Permit Type	Permit Number	Opened Date
Building/Residential/Alteration/SFD	B24004109	10/26/2024
Description of Work		
SFD/Alterations for completing the unfinished basement with bedroom, laundry room, bathroom, wet bar, media room, recreation room, exercise room, game room. APPROX 2100 SF**NOT APPROVED AS ACCESSORY APT, SMOKE DETECTORS REQUIRED, SUBJECT TO FIELD INSPECTION**

Rev #2 (B24004109)
15608 Linden Grove Ln.
Approved Basement Fr
11/6/24 H.O.

From: Oswald Jr, Woodin
Sent: Wednesday, November 6, 2024 9:48 AM
To: Satya R
Subject: RE: B24004109_15608 Linden Grove Lane

Basement Proposed Plan

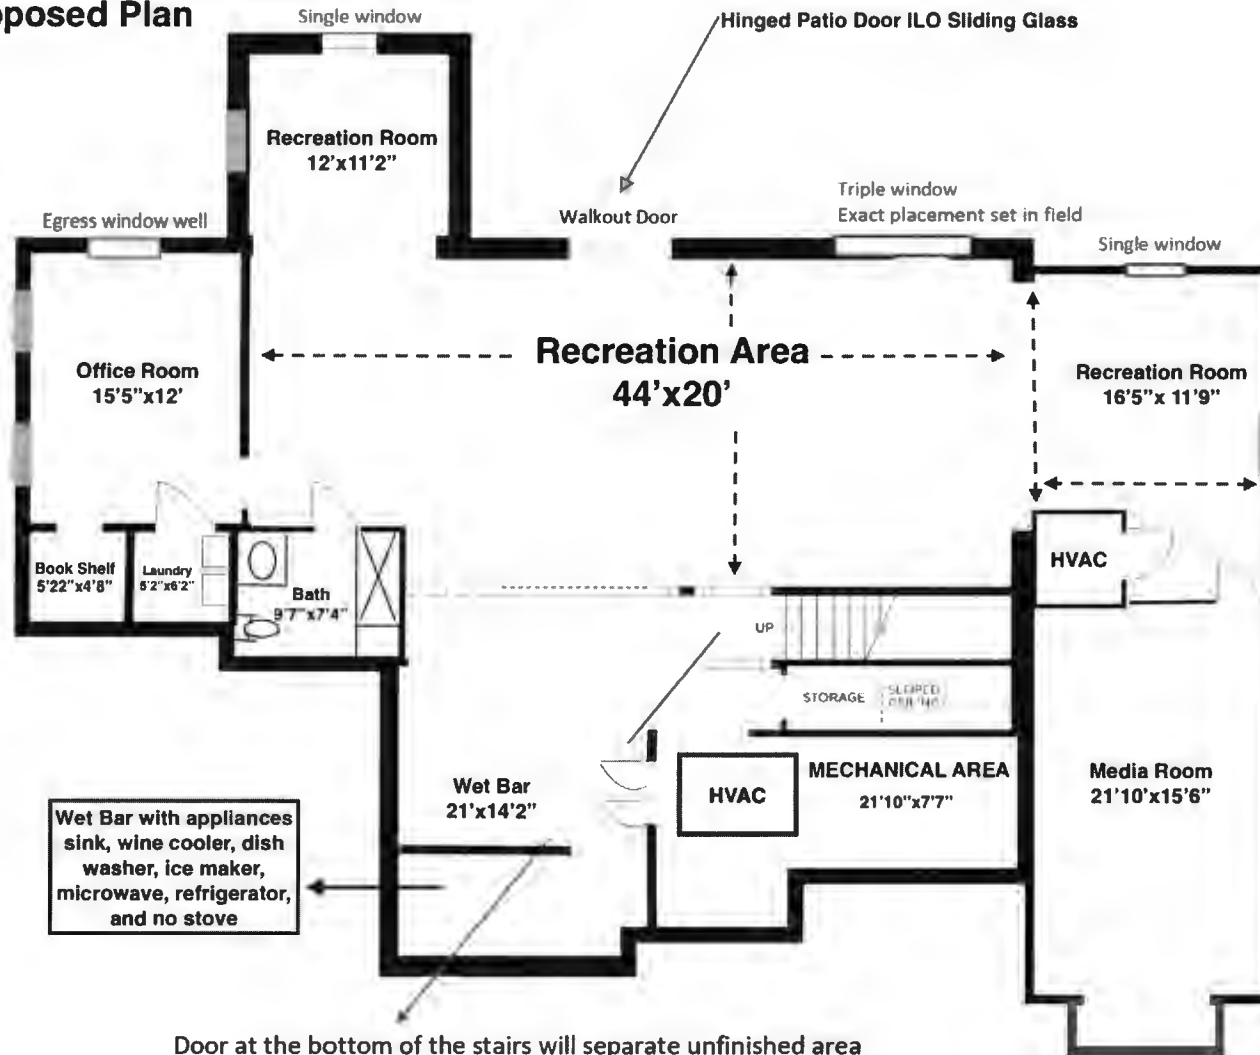
Good morning. The black boxes/rectangle are now gone on the revision uploaded to DILP. I see that you labeled the previous space called "Closet" with "Book Shelf". I also noticed no door into the room now labeled "office room" (previously labeled bed room). You need to show & label "permanent built in book case units" around the perimeter of the room in the space previously called "Closet". In addition, you also need to show and label the entry into the room "Cased opening 4 foot wide without a door" for it to not count as a bedroom.

One of the easiest ways to modify a bedroom is to show a cased 4 foot wide opening into the room without a door, and no closet. Another way to alter a bedroom is to show permanent book shelving units, desk or other permanent features around the perimeter of the room, and no closet.

If you opt to change the # of bedrooms by revising the existing or proposed floor plan, a copy of the revised floor plan must be uploaded to permit system. On the revised floor plan, please provide a note next to the change you intend to make to the room and show the change on the plan.

I reviewed the latest basement floor plan that shows the cased 4 foot wide opening without a door into the room labeled "office". It also shows permanent book case units in the area previously labeled closet. Based on these changes, the room no longer meets the definition of a bedroom. The floor plan remains at 5 bedrooms which is what the septic system was designed for.

Proposed Basement FP
Hinged Patio Door ILO Sliding Glass (B24004109)
15608 Linden Grove Ln

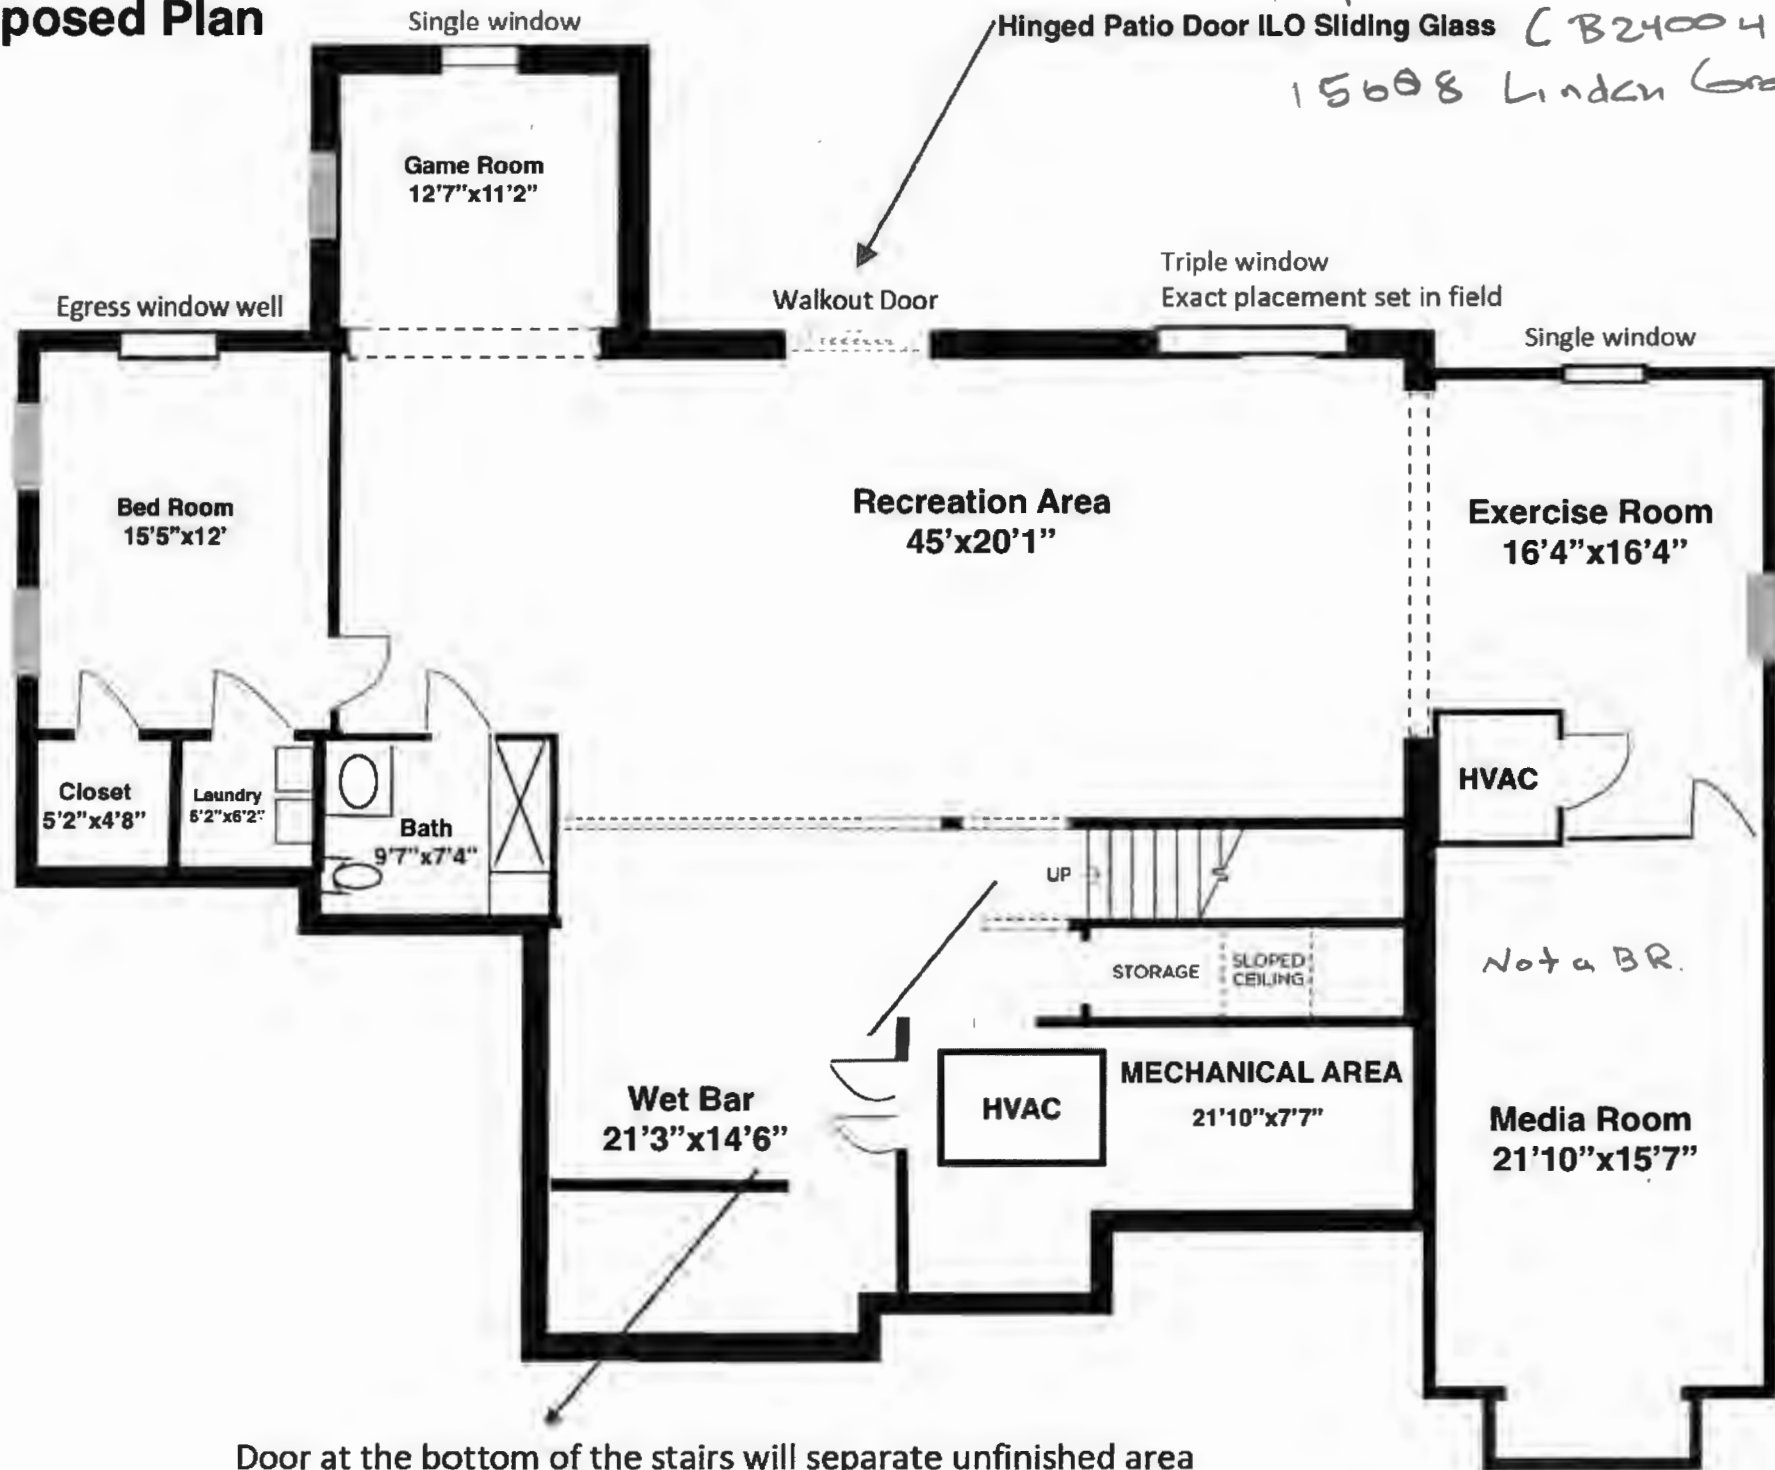
Door at the bottom of the stairs will separate unfinished area
